Final Safety Evaluation Report

Related to the Combined
Licenses for Vogtle Electric
Generating Plant, Units 3
and 4

Docket Nos. 52-025 and
52-026

Figure 2.4-3. HEC-HMS Drainage Basin Configuration
(As received from the applicant)

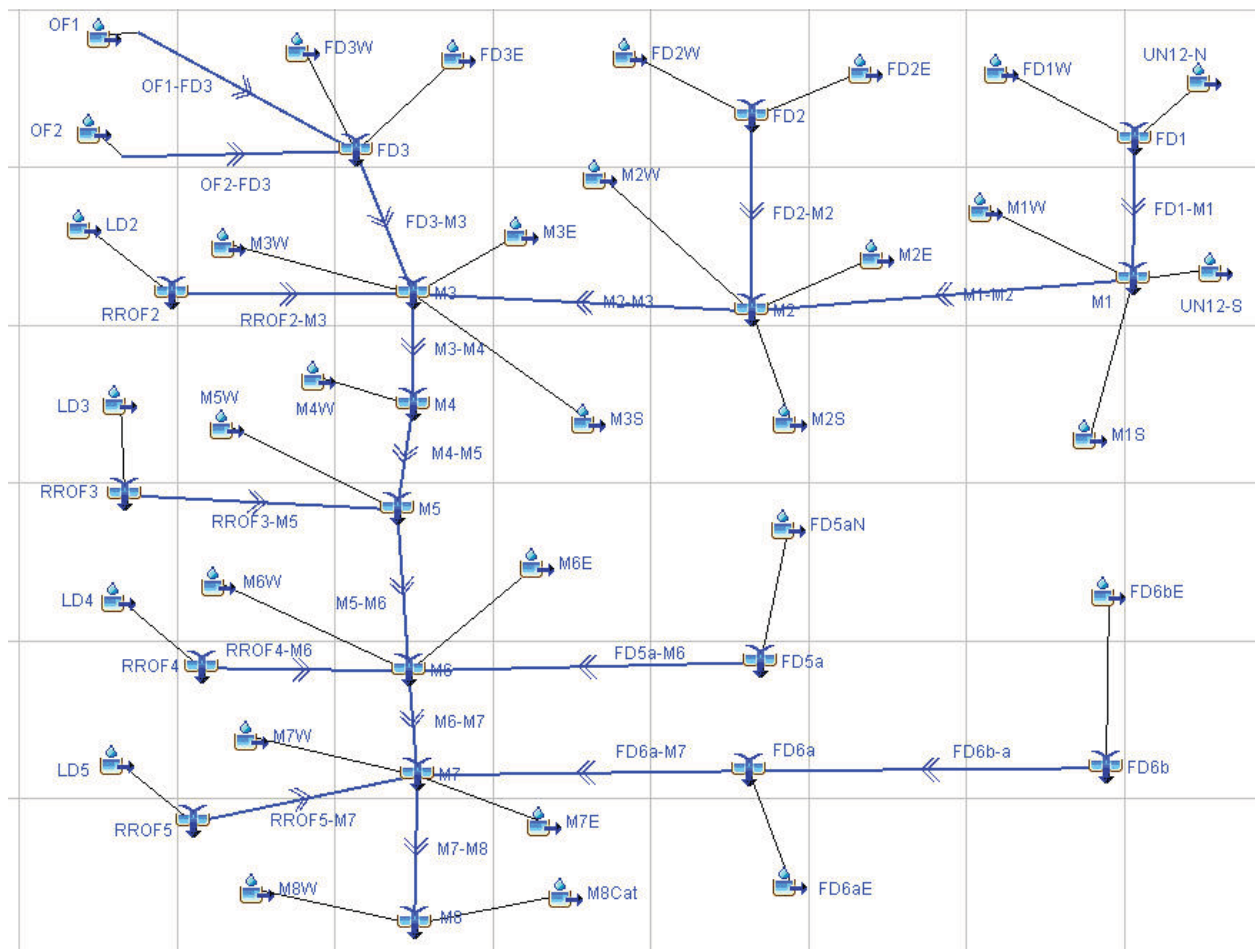
The applicant provided responses to the four items identified in RAI 2.4.2-1. Item 1 of the RAI requested clarification regarding channels presented in VEGP COL FSAR Figure 2.4-201 that were not included in the HEC-RAS hydraulic analysis of the localized probable maximum precipitation (PMP). The applicant stated in its response to the RAI that only the channels affecting flood levels in the power block are simulated in the HEC-RAS analyses. Other channels and drainage areas were included as contributors of flow from the local intense PMP (SER Figure 2.4-2). These channels are Feeder Ditch 5 and the ditch to the east of Feeder Ditch 1. The applicant's response included statements describing the process of including flows from these other sub-basins in the hydraulic analysis. SER Figure 2.4-3 (from the applicant-provided HEC-HMS files) shows the drainage area connectivity. Based on the applicant-provided HEC-HMS model, SER Table 2.4-2 shows the drainage areas that contribute to the flow in the ditches. The applicant also illustrated the connectivity of the drainage areas in SER Figure 2.4-2 by the identification of HEC-HMS nodes and sub-basins. The staff reviewed

Figure 2.4-4. HEC-RAS Water Surface Elevation Profiles for the Applicant's Model Setup

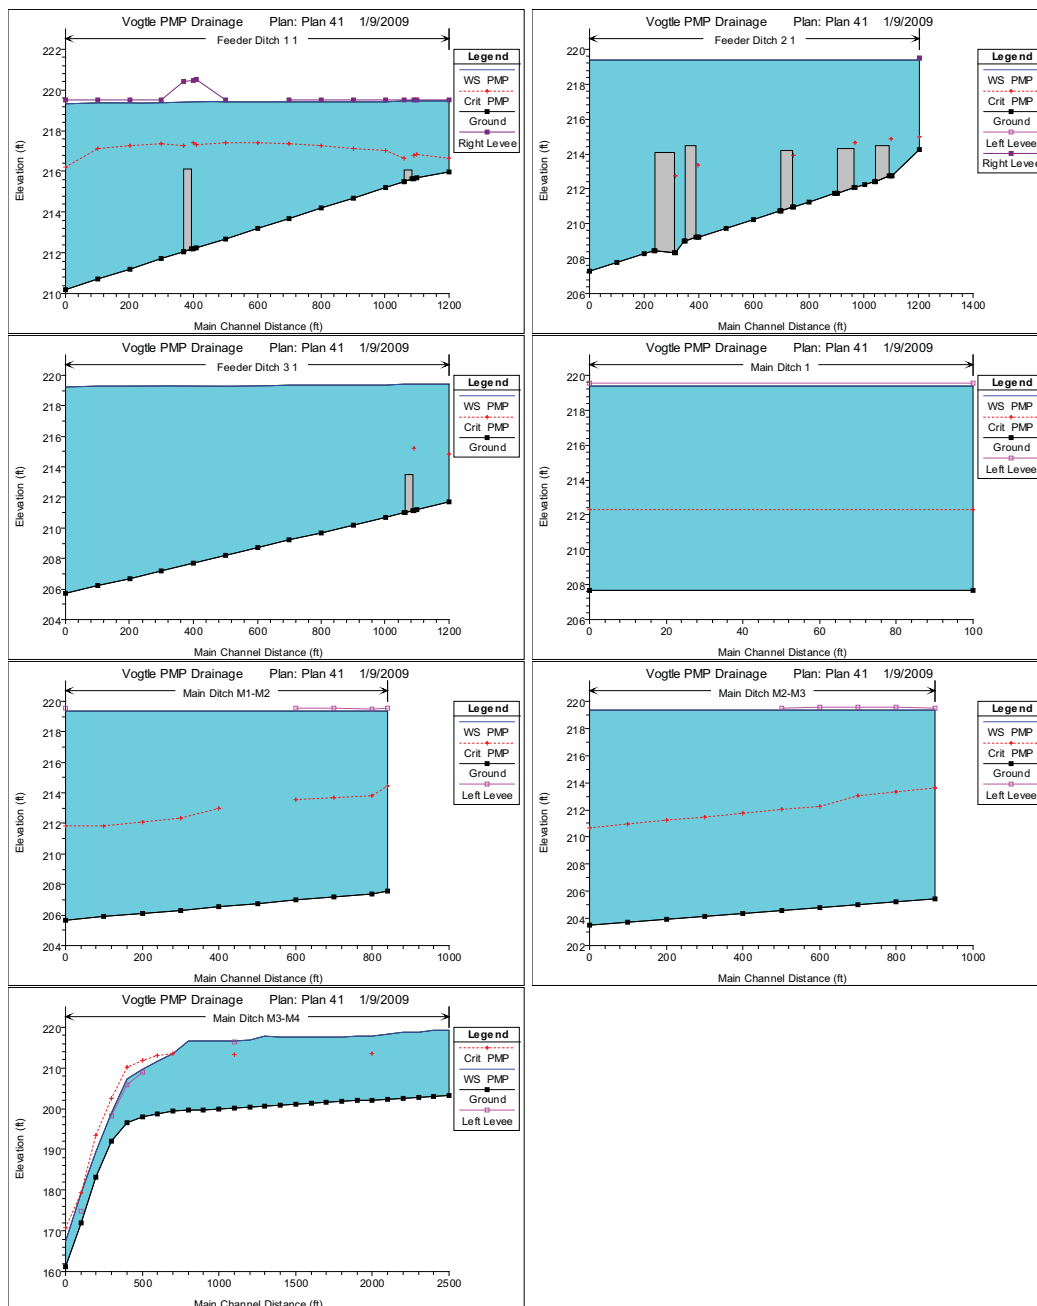
The applicant ran the HEC-RAS model under a mixed flow regime, indicating that both sub- and super-critical flows were expected to occur. As shown in SER Figure 2.4-4, extensive backwater conditions were produced in the feeder and main drainage ditches in the applicant's HEC-RAS model setup. At the downstream reach of the main drainage ditch, the water surface has a steep hydraulic gradient, and super-critical flows occur. Because this hydraulic feature occurs away from the safety-related structures, this super-critical flow occurrence is not relevant

The applicant states in VEGP COL FSAR Section 2.4.2.3 that the local PMP flood elevation produced by its HEC-RAS model is 219.45 ft MSL, which is 0.55 ft below plant elevation (220 ft MSL). This is the water surface elevation at the upstream end of Feeder Ditch 1. Water surface elevation profiles are shown in SER Figure 2.4-4.

Figure 2.4-5. Basins Drainage Plan with all Culverts and Heavy Haul Road Identified
(Based on VEGP FSAR Figure 2.4-201 and provided by the applicant in response to
RAI 01.04.02-1, Items 2 and 4)

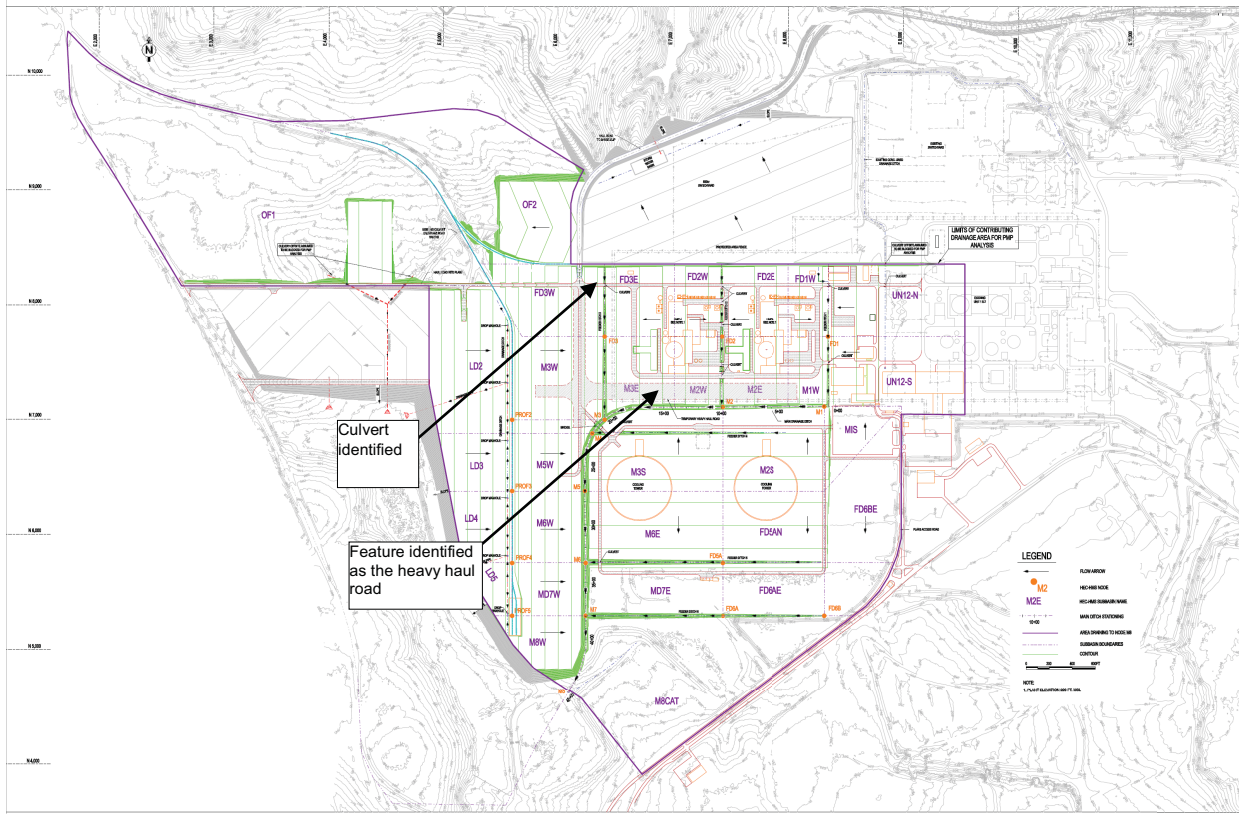
The staff's review of the HEC-RAS input files determined that a culvert within Feeder Ditch 3 is included in the model, but it is not included in VEGP COL FSAR Figure 2.4-102. RAI 2.4.2-1 requested the map be revised to identify all culverts and additional information on these features. SER Figure 2.4-2 also shows a surface feature that appears to cover Feeder Ditches 2 and 3 at their downstream ends, but no such feature appeared in the HEC-RAS input files. The staff also identified that the access road over Feeder Ditch 4 did not include a culvert, although it did include the Feeder Ditch 4 channel. The staff conducted a sensitivity analysis by blocking the channel and simulating the access road crossing as an inline weir (as with the other blocked culvert simulations completed by the applicant). This analysis produced only a small increase (0.01 ft) in water surface elevation in Feeder Ditches 1 and 2 and in the main ditch. The staff requested that the applicant's HEC-RAS model and results be updated by blocking the culvert in Feeder Ditch 4 and that these results be included with the FSAR. The applicant provided an updated HEC-RAS file under a supplemental response letter to RAI 2.4.2-1 dated August 5, 2009. The staff verified that Revision 2 of the VEGP COL FSAR adequately addressed the above discussion.

Item 2 of RAI 2.4.2-1 refers to a culvert included in the HEC-RAS model in Feeder Ditch 3 that is not included in VEGP COL FSAR Figure 2.4-201. Also, the fourth item of the RAI refers to an unknown feature shown in VEGP COL FSAR Figure 2.4-201. The applicant provided an updated figure in the response indicating the location of the culvert, SER Figure 2.4-5 (corresponding to VEGP COL FSAR Figure 2.4-201). The updated figure also identifies the unknown feature as a heavy haul road. The haul road would be used during construction and would have culverts placed in the drainage ditch to handle flows that occur during construction. The local PMP analysis was done for the operational condition in which the heavy haul road would have been removed. The applicant updated this figure in a letter dated March 27, 2009. The RAI response also included a discussion concerning the culvert at the downstream end of Feeder Ditch 4, in which the applicant states inclusion of the effect of a blocked culvert at this location would be minimal. Sensitivity analyses by staff confirmed this assertion as discussed previously. Therefore, Item 2 of RAI 2.4.2-1 is closed.

RAI 2.4.2-1, Item 4 requested clarification concerning a surface feature in Feeder Ditches 2 and 3. The applicant provided an updated figure in the response, which indicates the location of the culvert and which is shown in SER Figure 2.4-5 (corresponding to VEGP COL FSAR Figure 2.4-201). The applicant provided this information in a letter dated March 27, 2009. The staff verified the updates to the FSAR for the inclusion of the updated Figure 2.4-201; therefore, RAI 2.4.2-1, Item 4 is considered closed.

Figure 2.4-6. Basins Drainage Plan with Cross Section Locations Used in the HEC-RAS Analyses

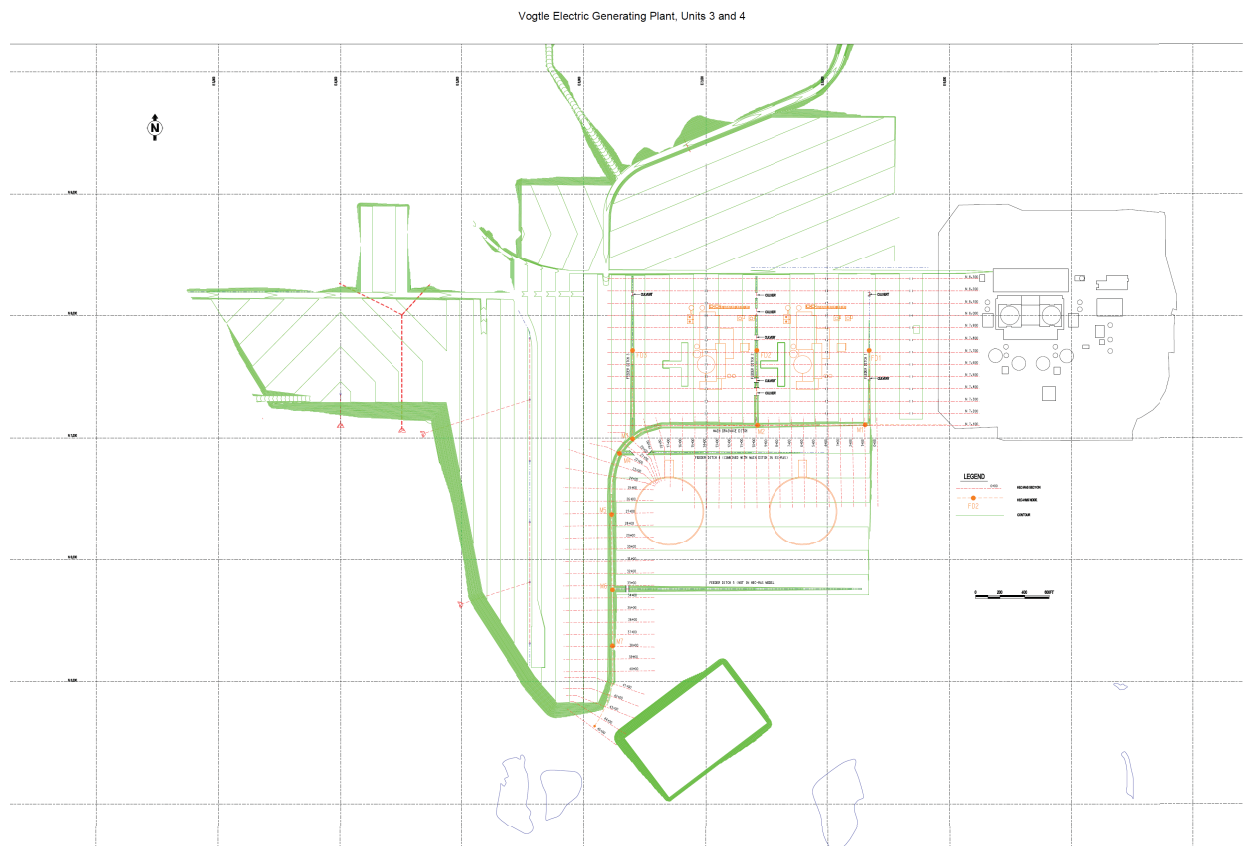
RAI 2.4.2-1, Item 3 asked for a figure that includes the locations of the cross sections used in the HEC-RAS analyses. The applicant provided a figure in the response, SER Figure 2.4-6 (corresponding to VEGP COL FSAR Figure 2.4-201a). The applicant also provided proposed

text for the revised FSAR to include the figure under letter dated March 27, 2009. The staff verified the updates to the VEGP COL FSAR, Revision 2 for inclusion of the updated Figure 2.4-201a; therefore, RAI 2.4.2-1, Item 3 is considered closed.

Figure 2.4-7. Basins Drainage Plan with Cross Section Locations Used in the HEC-RAS Analyses

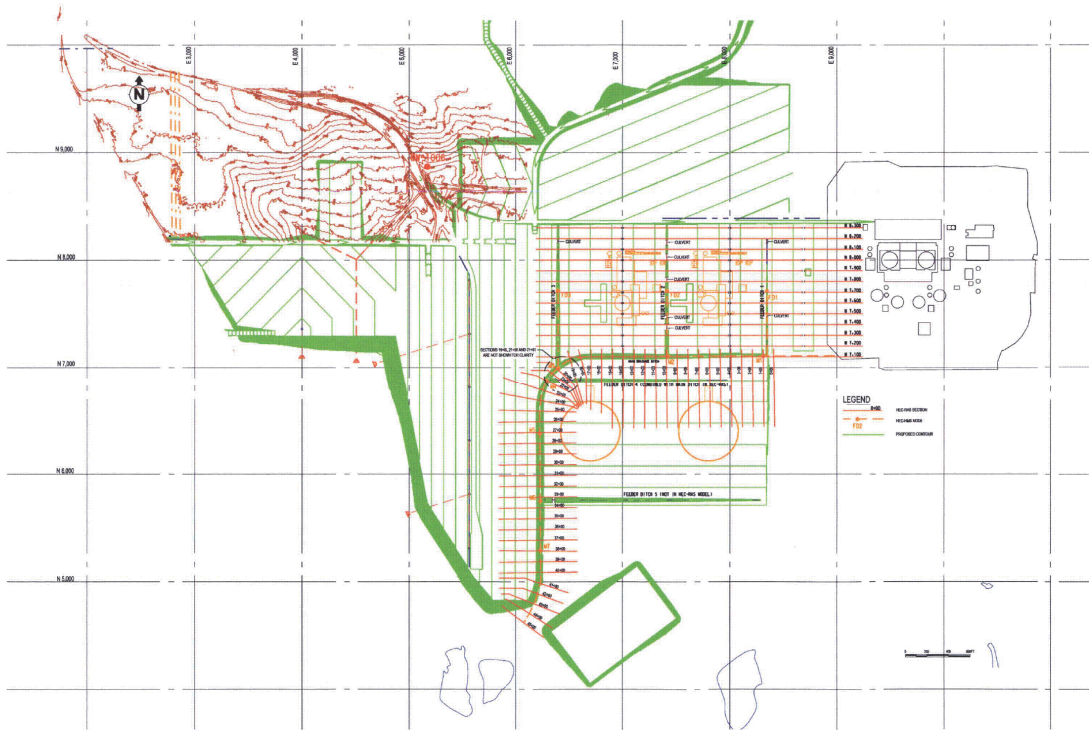
- Updates to the maximum probable maximum flood (PMF) elevation discussion for the local intense precipitation event.
- Assumptions made in the hydraulic analysis concerning surface material type, conservative analysis of culverts with complete blockage, and use of steady-state flows, which is conservative.
- Updates to the discussion concerning flow regime (sub- and super-critical) locations in the main stem ditch.
- Updates to VEGP COL FSAR Table 2.4-207 summarizing the revised HEC-RAS hydraulic model output.
- Updates of proposed VEGP COL FSAR Figure 2.4-201a reflecting the inclusion of the blocked culvert at the downstream end of Feeder Ditch 4 (SER Figure 2.4-7).
